Chapter 10

Items 10-1-12 through 10-39-12

June 14, 2013.

**Ballot Comment and Proponent Comment Agenda- July 15-19, 2013:
Proposals of 2012 submitted on the ICC A117.1-2009**

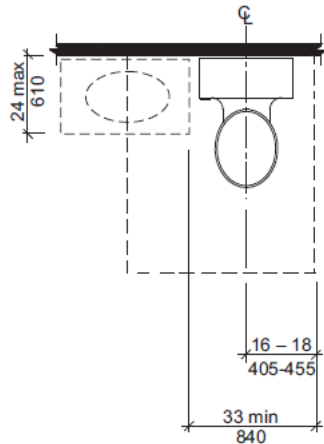
Reason: The quantity of change proposals submitted by International Code Council is reflective of three elements of our work: 1. ICC is the Secretariat for the Standard and some changes reflect inconsistencies or improvements suggested by staff; 2. ICC develops and publishes a Commentary on the standard and writing the commentary illuminates issues of the text and figures; and 3. ICC provides an interpretation service for the standard which results in the observation of provisions the users find most confusing.

This is simply a clarification that may be helpful given several changes that occurred in the 2009 edition and dealt with the way the word “and” was used for requirements. This perceived problem may be caused by being too code literal, but the use of the word “and” as the conjunction does raise the question as to whether the encroachment is only allowed for situations where both the water closet and lavatory exist or whether the encroachment is also allowed when only one of those fixtures is within the space.

(d) Clearance with lavatory overlap

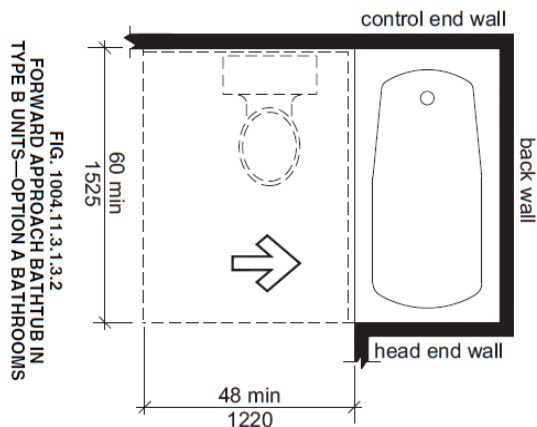
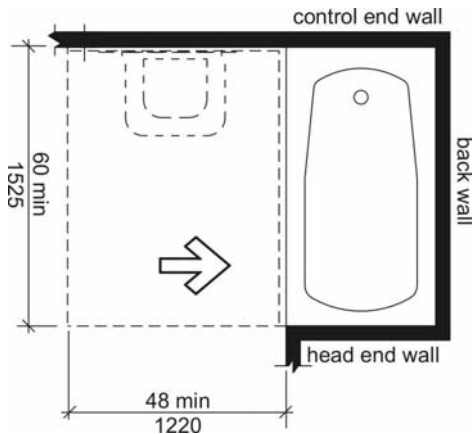
Because of the word “and” in the phrase “a water closet and a lavatory” it may be assumed to require both fixtures and not allow a water closet OR a lavatory. The word “and” is good because if you provide both a WC and a lav along the end wall you could end up with both of them extending into the required clearance (the first would be in it completely and the second would encroach just a bit based on the clearance between fixtures). [See fig. 1004.11.3.1.2(d) below for example of how both fixtures may encroach.]

Changing the word “and” to be “or” would seem like a possibility but that would not accept the second fixture extending into the space as discussed above. Because the text needs to accept either one fixture or both fixtures in the space, it may need to be changed to something like what is shown in the two options.
